Product / Process Change Notification (PCN)

PCN #: PCN_SwTASV_20180716

Affected Series: 430 1X2 XXX 8X6

Old Injection Mold – Design	New Injection Mold - Design
Bottom View		
Side View

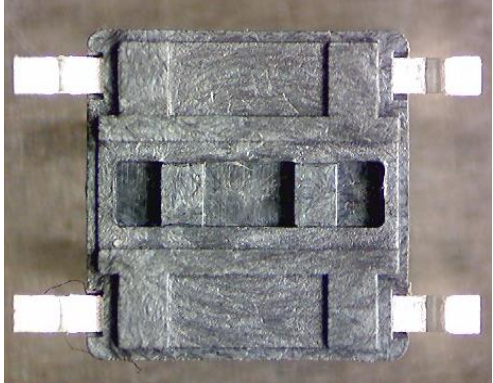
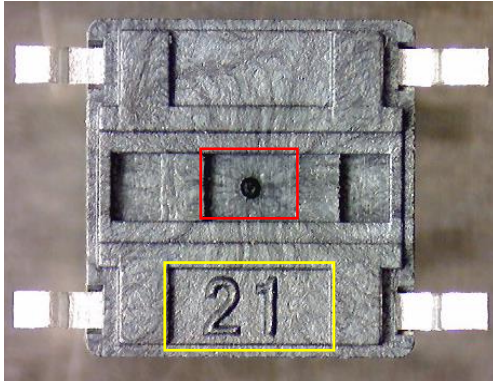
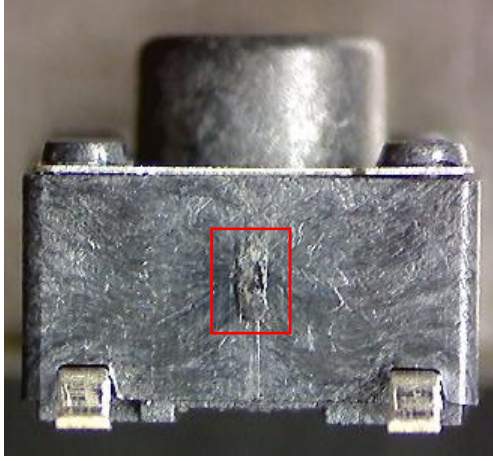
- Due to injection point position (gate) and polymer melt flow, the visual surface appearance of the frame can change a little bit. (See the red square in the pictures below)
- Additionally cavity numbers were added to the bottom of the frame. (See the yellow square in the pictures below)
- Affect part number as listed.

In order to ensure the product quality and reliability, Würth Elektronik will replace the existing injection mold for the frame, that cannot fulfill our quality and reliability requirements anymore. Therefore Würth Elektronik will build a new injection mold with an improved polymer melt flow by changing the position of the injection point (gate) for the frame.
